## **Bi-weekly Seismic Call Agenda**

**Date:** 2016-05-03

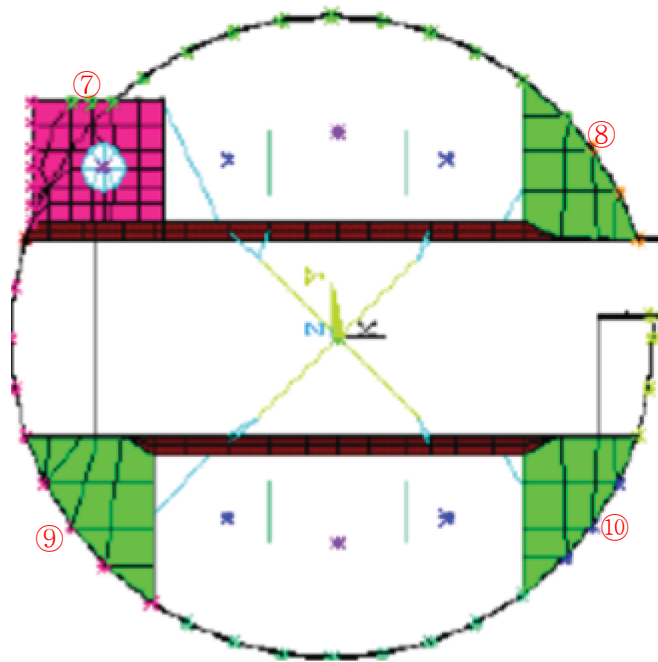
KHNP is to determine what slabs have been included in the live load study, re-perform the study if all slabs have not been included, and revise the RAI response to describe the modeling of all slabs and discuss the treatment of live loads with regard to those slabs (justify if excluded).

There are some small horizontal surfaces in the reactor containment building other than those horizontal surfaces between the secondary shield wall (SSW) and the containment shell. The small horizontal surfaces which are not between the SSW and the containment shell are modeled in the reactor containment building seismic analysis model. The following figure shows the horizontal surfaces modeled in the reactor containment building seismic analysis model compared to those those horizontal surfaces shown in DCD Tier 2, Figure 1.2-

2, "General Arrangement Reactor Containment Building Section A-A" on page 1.2-48, which was referred to by the NRC staff during the last bi-weekly seismic call.

In addition to the six horizontal surfaces shown in the figure above, four horizontal surfaces also exist in the reactor containment building, as shown in the figure below.

Since the ten horizontal surfaces labeled above are relatively small, the seismic live loads of those surfaces were ignored in

the last study for evaluation of seismic live load effect on seismic response of the reactor containment building.

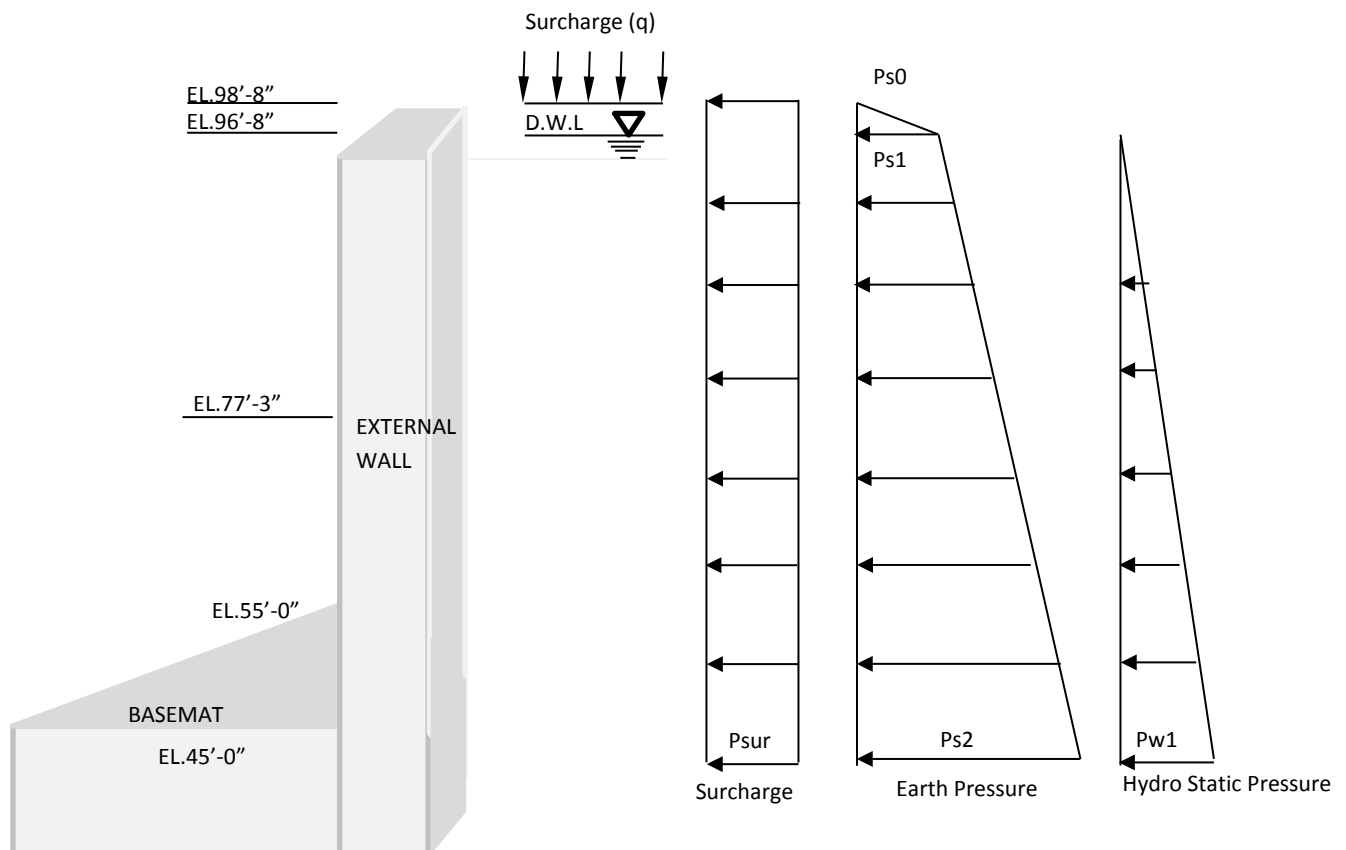
KHNP is to explain why  $L_g$  is only applied up to two feet below grade.

The soil and surcharge load ( $L_g$ ) include hydrostatic pressure, surcharge load, and earth pressure. The response in RAI 227-8274 Question 03.08.04-4 is focused on the description of the water pressure, so the response explains the height for the hydrostatic pressure. The hydrostatic pressure is applied up to two feet below grade. Earth pressures are applied up to the grade level, as shown in the figure below.
